## Oakley City Planning Commission Staff Report

### PRELIMINARY PLAT – Oakley Bench Subdivision Applicant: Wes Harwood

**To:** Oakley City Planning Commission  
**From:** Stephanie Woolstenhulme, City Planner  
**Date of Meeting:** August 3, 2022  
**Type of Item:** Preliminary Plat – Possible Action. Public Hearing held August 3, 2022.  
**Process:** Administrative Review

WATERLINE ALIGNMENT PROFILE

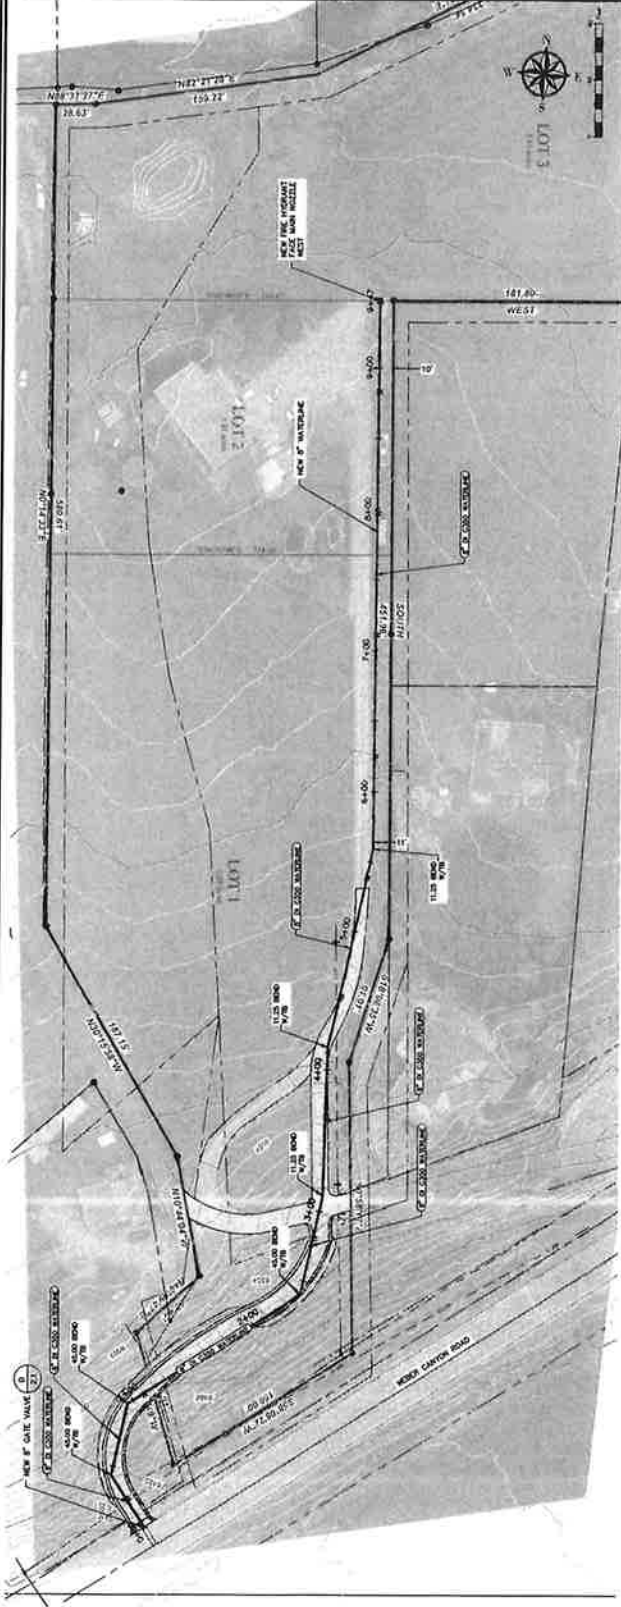
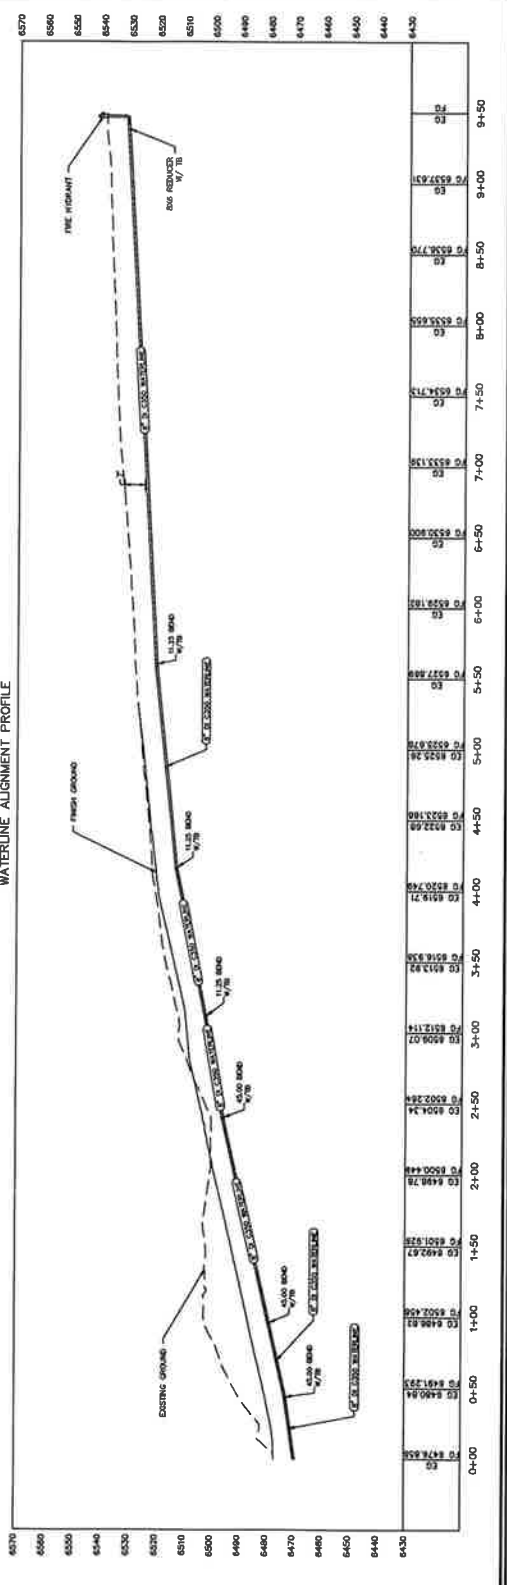
1. Sewer is not a good option due to the uphill tie in at Oakley Bench Estates. Septic recommended.
2. Waterline must be tied-in to water main in cul-de-sac of Oakley Bench Estates and taken back to Weber Canyon Road.
  - a. Waterline cannot come up from Weber Canyon and dead end. Pressure will not be sufficient.
    - i. Pumps in-house cannot be used on a municipal line.
    - ii. City will not want to assume ownership of a pumphouse at bottom of hill, especially for 2 (possibly 3) lots.
  - b. The line in Oakley Bench Estates is a 6" line, but line for this project should be 8" for hydrant flow. Waterline will increase from the 6" line to 8" line all the way to tie-in at Weber Canyon. A looped line will actually benefit the entire system.

6. Water Line Extension agreement signed giving ownership of water main to Oakley City after construction.
7. Water line design be constructed per the drawings including, but not limited to:

- b. Installation of fire hydrants at 4+00, 8+00 and end of line.
  - c. Air/Vac valve at end of line.
